1 July 2008

Ref: It5558prh080701-letter climate change.doc

## **45 HEARNS LAKE ROAD WOOLGOOLGA, UPDATED CLIMATE CHANGE ESTIMATES AND EFFECT ON COASTLINE HAZARDS**

**Figure 1: 2108 Hazard Line and ZRFC at subject property for mid and high estimate sea level rise scenarios**

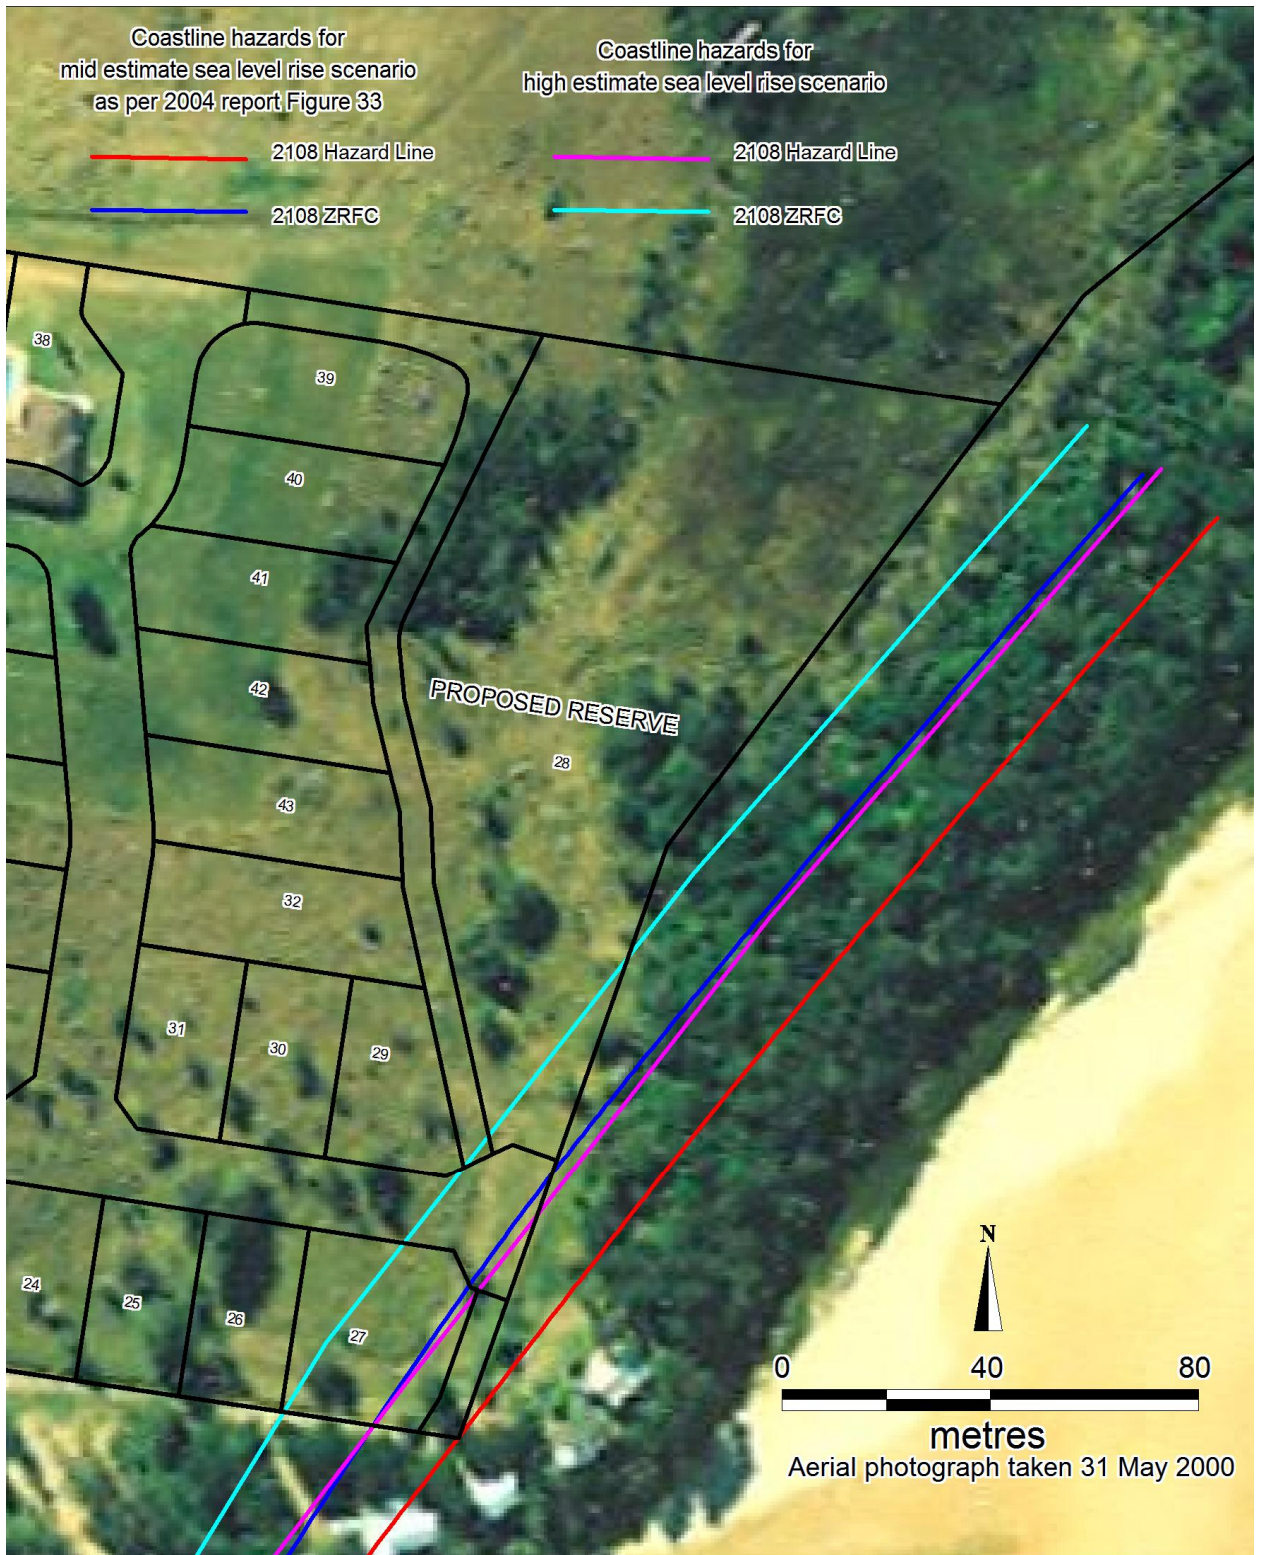
- "The EA [Environmental Assessment] does not consider the latest climate change scenarios. Reference should be made to the latest Intergovernmental Panel on Climate Change [IPCC] Report: The AR4 Synthesis Report, 'Climate Change 2007', released November 2007. The Coastline Hazard report and the Stormwater Quality Management Strategy should be updated accordingly.
- In particular further comment is needed on how the design of this proposal responds to likely impacts resulting from predicted sea level rise and intensity of rainfall events."

In Figure 33 of our 2004 report, the 2104 Hazard Line and Zone of Reduced Foundation Capacity (ZRFC) at the subject property were presented. This was based on a sea level rise of 0.5m. An update of this Figure 33 is below as **Figure 1**, with addition of the 2108 Hazard Line and ZRFC relating to the highest estimate sea level rise of 0.91m<sup>1</sup>. These high estimate lines are about 14.3m landward of the mid estimate lines, based on a setback of 16.4m for sea level rise variation, but discounted by 2.1m as per Section 6.4.3 of the 2004 report<sup>2</sup>.

The conclusions of our 2004 report remain unaltered. That is, given that the 2108 Hazard Line is seaward of the subject property for a mid estimate sea level rise and 100 year planning period, the location of the proposed development is considered to be reasonable from a coastal engineering perspective.

If the Department of Planning considers that it is appropriate to apply the high estimate sea level rise and 100 year planning period, then again the overall subdivision and development is generally considered to be acceptable from a coastal engineering perspective.

However, the 2108 Hazard Line (for high estimate sea level rise) intersects the seaward portion of Lot 27. Although it is considered that it is reasonable for development to occur on this Lot at this time (given the long time frame for this hazard to be realised, and conservative and short-term<sup>3</sup> nature of the hazard), it is recommended that there is consideration of some restrictions on development on this Lot<sup>4</sup>. These could include:

- setting back development at Lot 27; and,
- requiring special foundations (such as piling) for residential building development at Lot 27 to take account of the ZRFC as per Nielsen et al (1992).

It is considered to be prudent to locate services assets (such as water and sewer mains, and telephone and electricity cables) landward of the 2108 Hazard Line based on high estimate sea level rise, since there is the opportunity to do so and still service all lots in the proposed subdivision.

There are not considered to be any particular coastal engineering requirements for the road turning circle between Lots 27 and 29, given that it is only just intersected by the 2108 Hazard Line based on high estimate sea level rise.
